# SERVICE BULLETIN

| Classification: | EM94-002                     | Section: | Engine Mechanical | Models: | See Below      |

## BROKEN EXHAUST MANIFOLD STUD

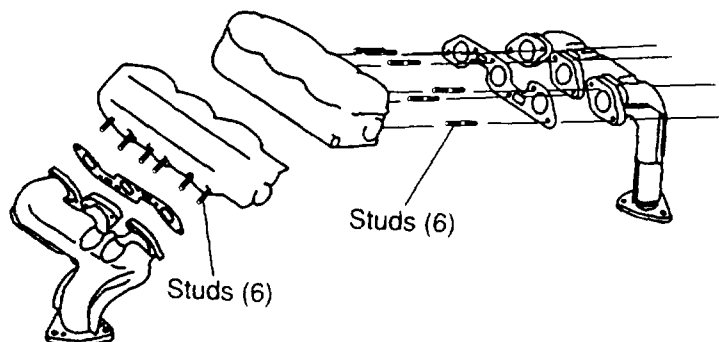
The exhaust manifold stud has been changed for improved durability. Use the following procedure to repair vehicles which exhibit excessive exhaust noise due to exhaust manifold stud breakage.

1. Remove the exhaust manifold on the side of the engine with broken stud(s). (Figure 1) For additional information, refer to the **EM** Section of the appropriate Service Manual.

2. Replace the broken stud(s) and the front and rear studs **only** using the **improved part, P/N 14065-V5003**.
3. Replace the exhaust manifold gasket and the exhaust manifold with new parts. Refer to the EM Section of the appropriate Service Manual for proper torque values for the fasteners. Refer to the Parts Catalog/Microfiche for applicable P/N's.
